The Learning Experience JSP16-19

Public Hearing at the request of Lockard Development, Inc. on behalf of The Learning Experience for Special Land Use, Preliminary Site Plan, and Stormwater Management Plan. The subject property is in Section 14 on 2.2 acres in the City of Novi. It is located on the northeast corner of Eleven Mile Road and Town Center Drive in the OSC (Office Service Commercial) zoning district. The applicant is proposing a 10,000 square foot daycare facility for 150 children and 24 employees with associated site improvements.

PLANNING REVIEW

Review Date: December 7, 2016
Review Type: Preliminary Site Plan
Project Name: The Learning Experience – Day Care Center
Plan Date: 12-1-2016
Prepared by: Kirsten Mellem, Planner
E-mail: kmellem@cityofnovi.org **Phone:** 248.347.0484

PRELIMINARY SITE PLAN

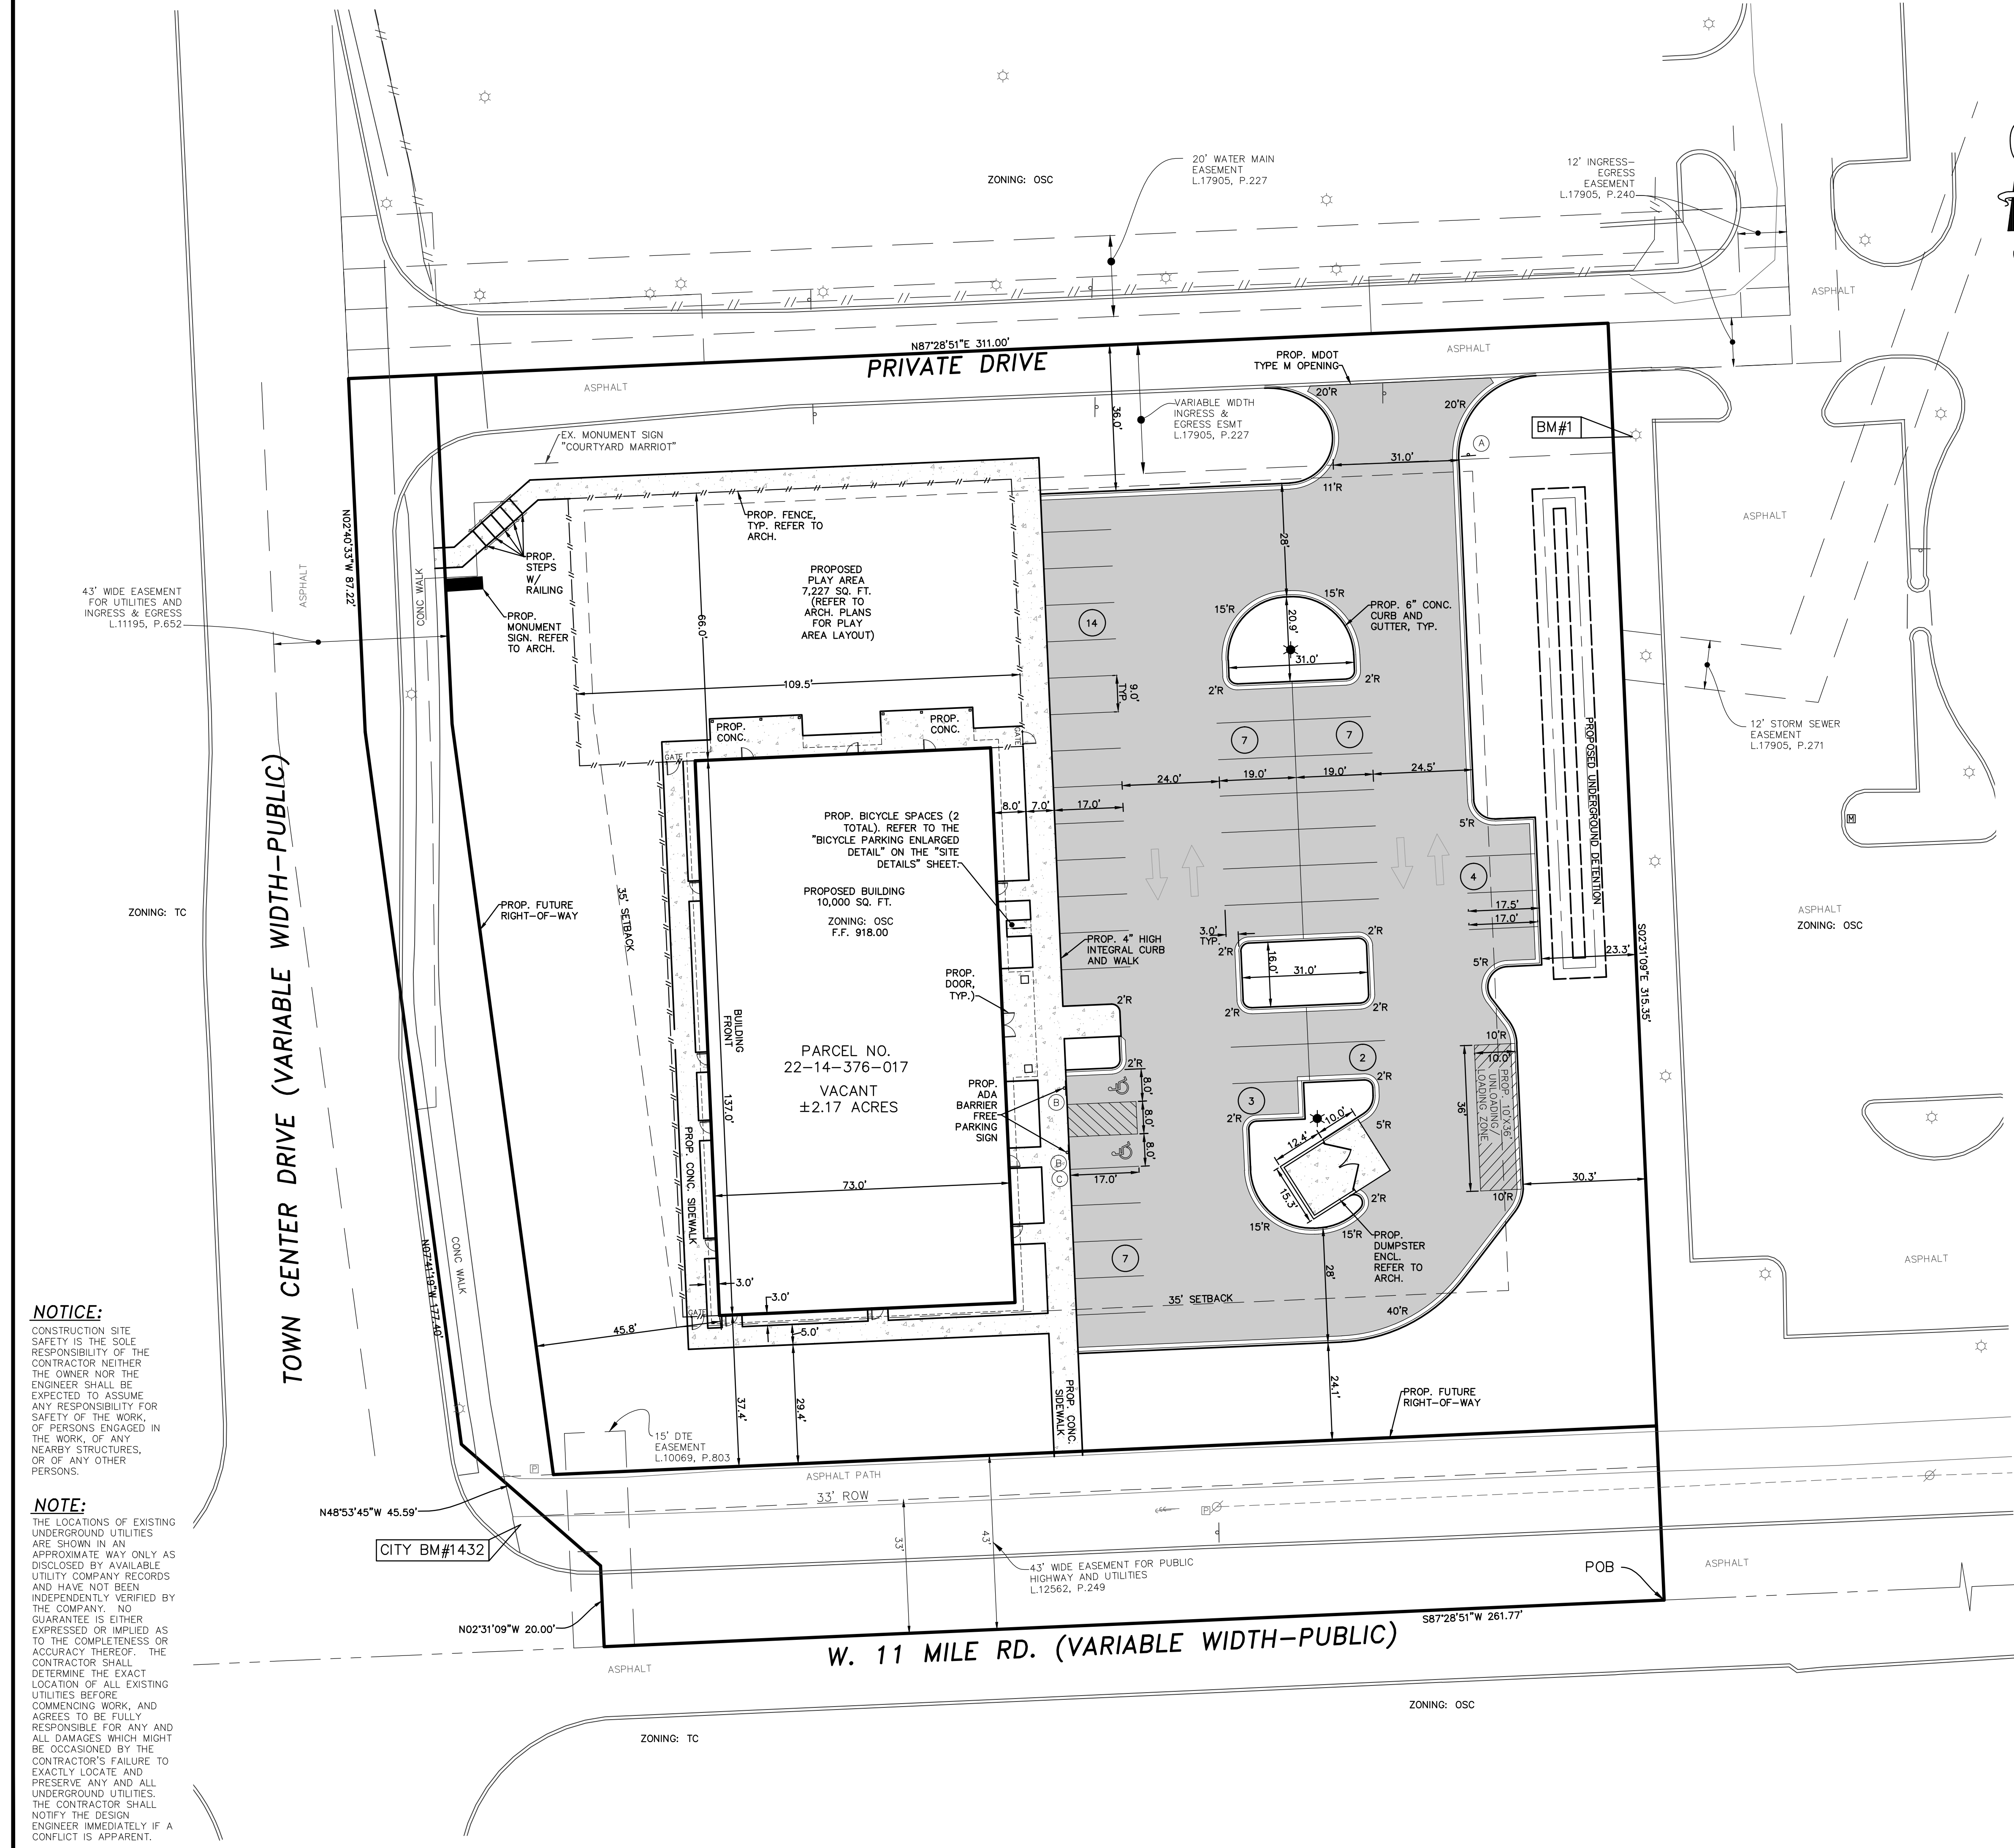
3. Exterior Lighting (Sec. 5.7): **Provide updated photometric plan that reflects the updated site plan.**
4. General Layout and Dimensions: **Provide updated Zoning Ordinance reference for Sheet 2 – General Notes - #4 – Section 2511 should be changed to Section 5.7.**

Response: Additional lighting will be provided to increase the lighting levels in the area indicated.
- **Comment:** *Sheet 2 General Site Notes #4 should reflect Sec. 5.7 instead of Sec. 2511.*

Response: General Site Notes - note #4 on Sheet 2 will be revised to Sec. 5.7.
- **Comment:** *Submit a Sign Permit Application to Jeannie Niland, 248-347-0438.*

Landscape Plan

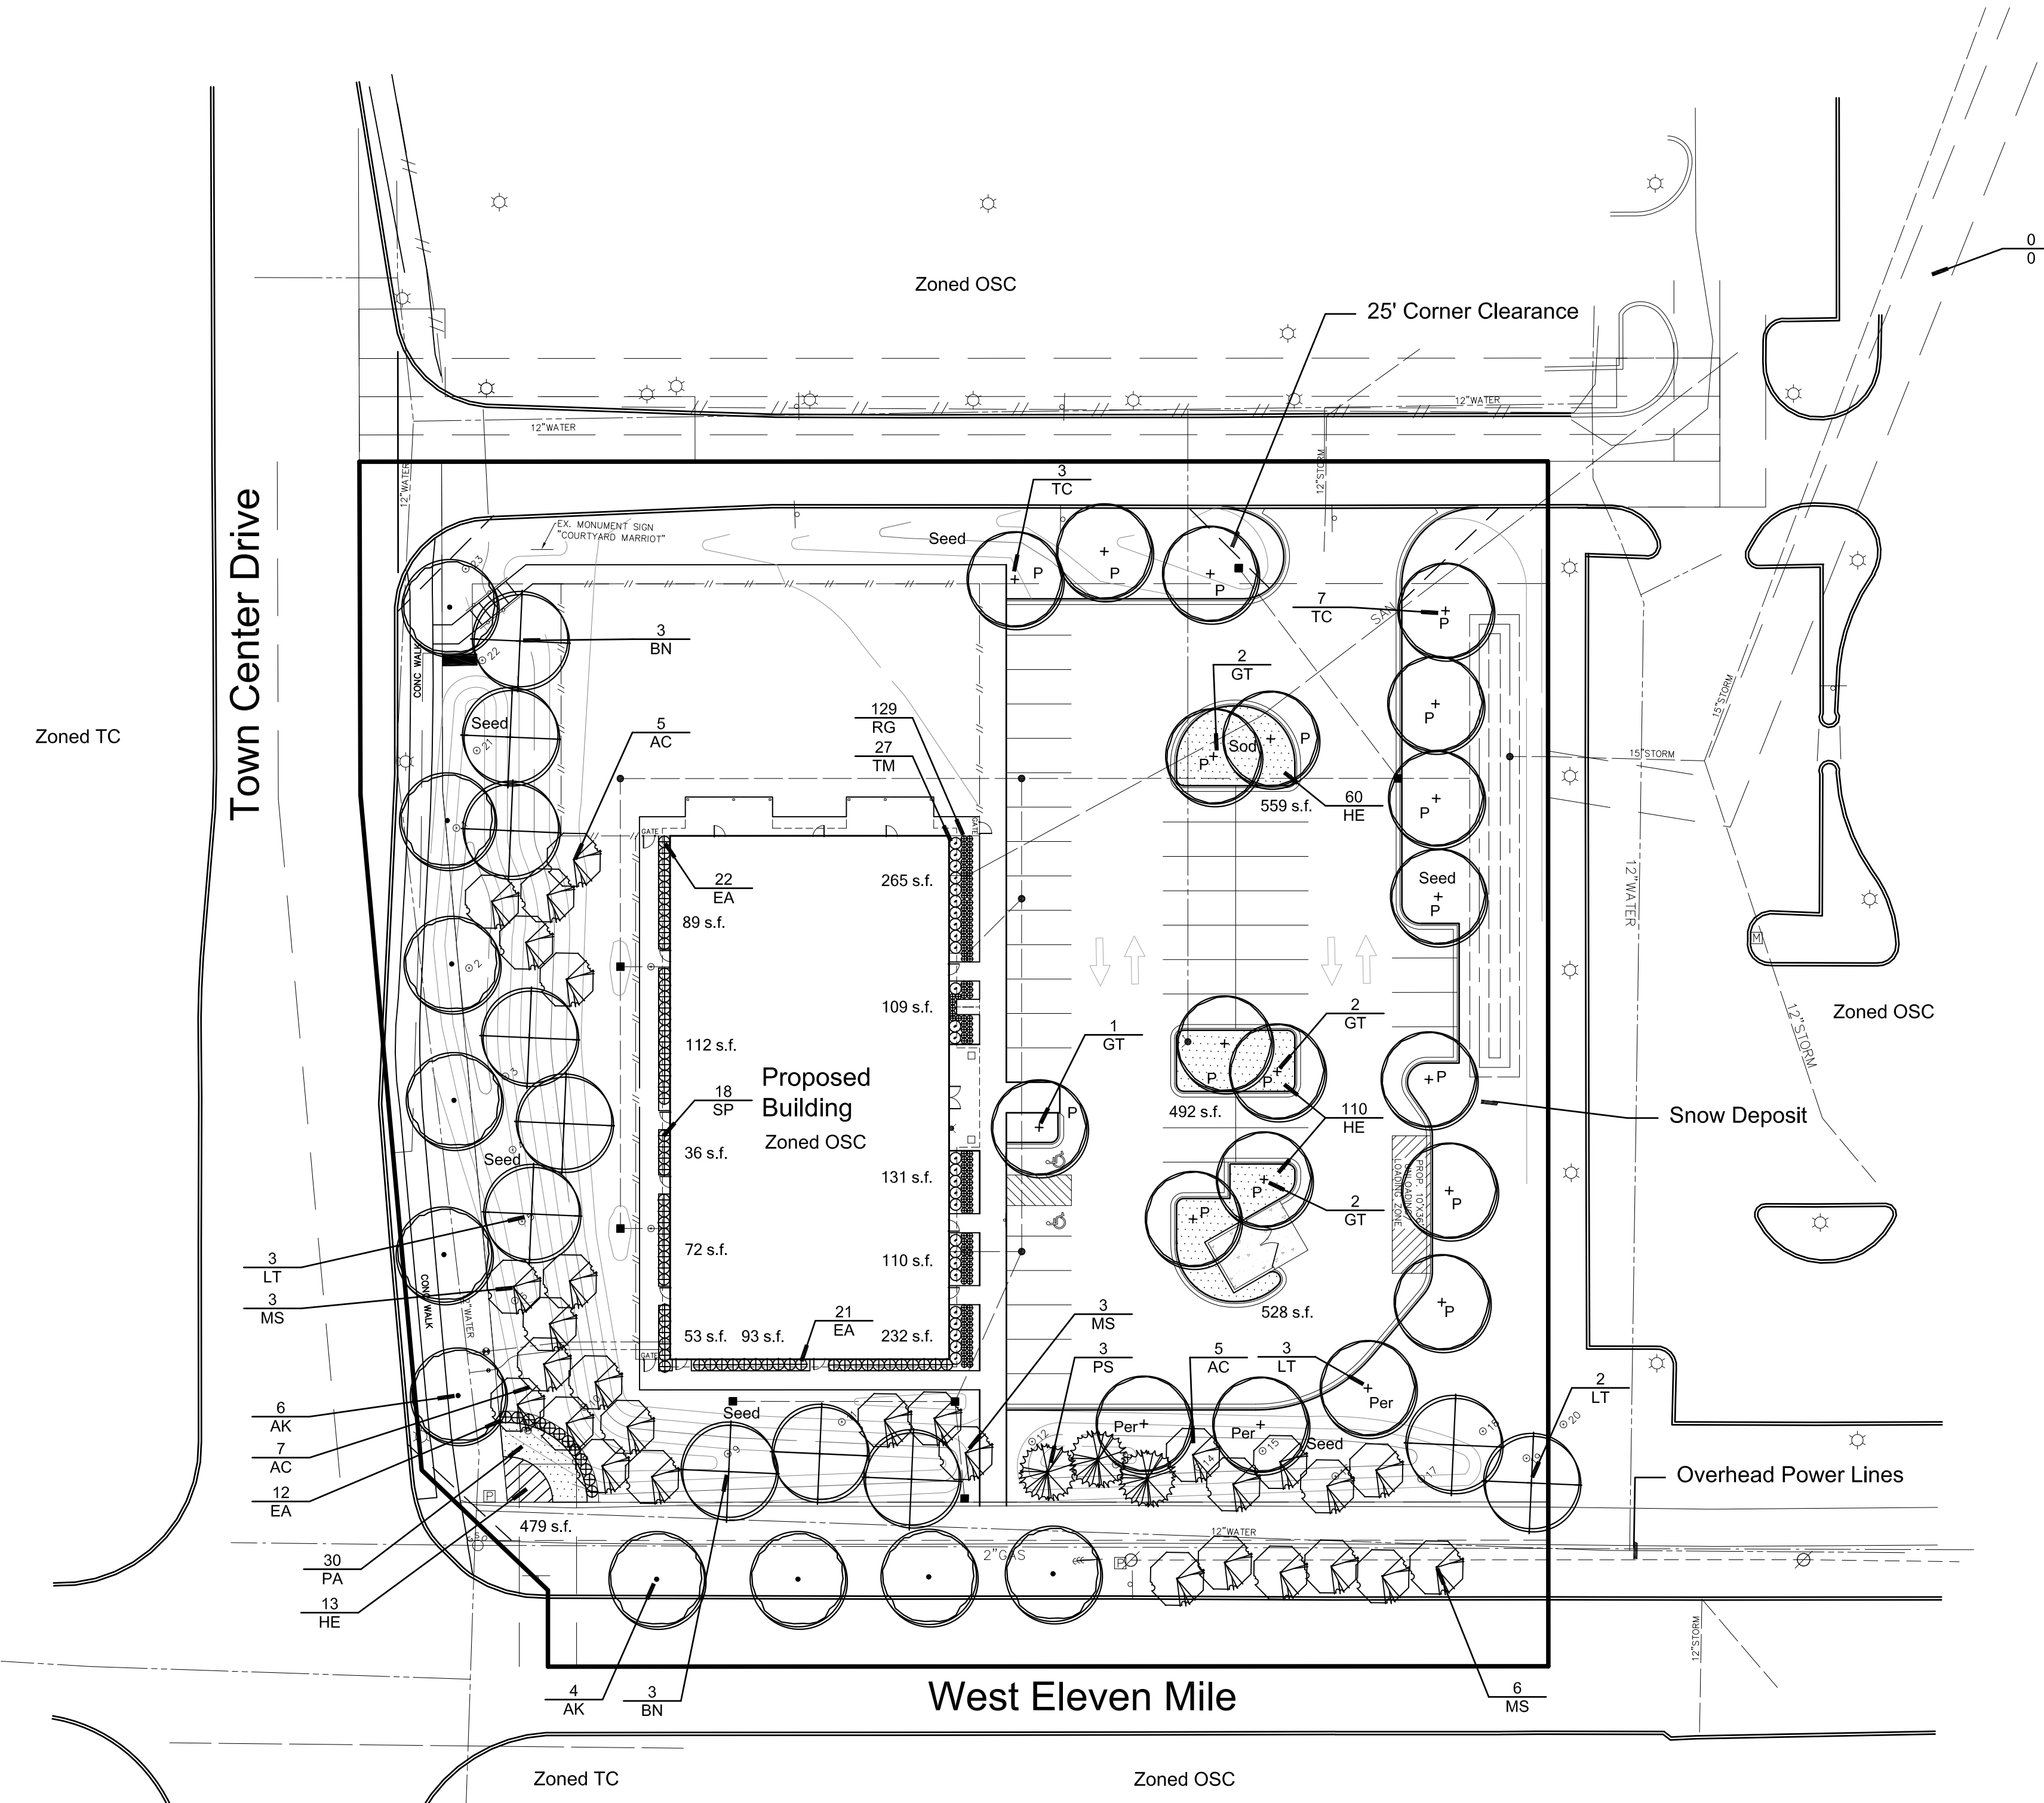
1. Based on the perimeter noted, 18 canopy trees are required and 3 are provided.
2. **A landscape waiver is requested for the 15 perimeter trees not provided. Approximately 6 of these could not be planted because of the play area and building. As the perimeter and parking lot are well-landscaped, even with this shortage, the waiver is supported by staff. To plant more canopy trees around the perimeter of the site than are already provided would be to the detriment of the trees.**

1. The requirement for at least 60% of the building visible from public roads has greenscape is greatly exceeded by the provided landscaping.
2. Based on the building perimeter, 3,360 sf of landscaped area is required around the building foundation. 1302 sf is provided at the building, 479 sf is provided at the southwest corner of the site and the interior parking islands, totaling 1579 sf, are planted with daylilies as extra landscaping.
3. A waiver is requested for the shortage in landscaping, and to place supplemental landscaping elsewhere on the site.
4. **The waiver request is supported by staff but more preferable locations for the daylilies, where they would experience less wear and stress would be along the front(s) of the berm(s) along the road(s). Please consider locating the daylilies along the fronts of the berms.**

1. The required utility box screening detail and a note regarding the need for screening are provided.
2. All plantings are at least 10 feet away from hydrants and utility structures on the plan.
3. **Please add call-outs to the trees nearest the hydrant or utility structure stating that they are to be at least 10 feet away from the hydrant or structure.**
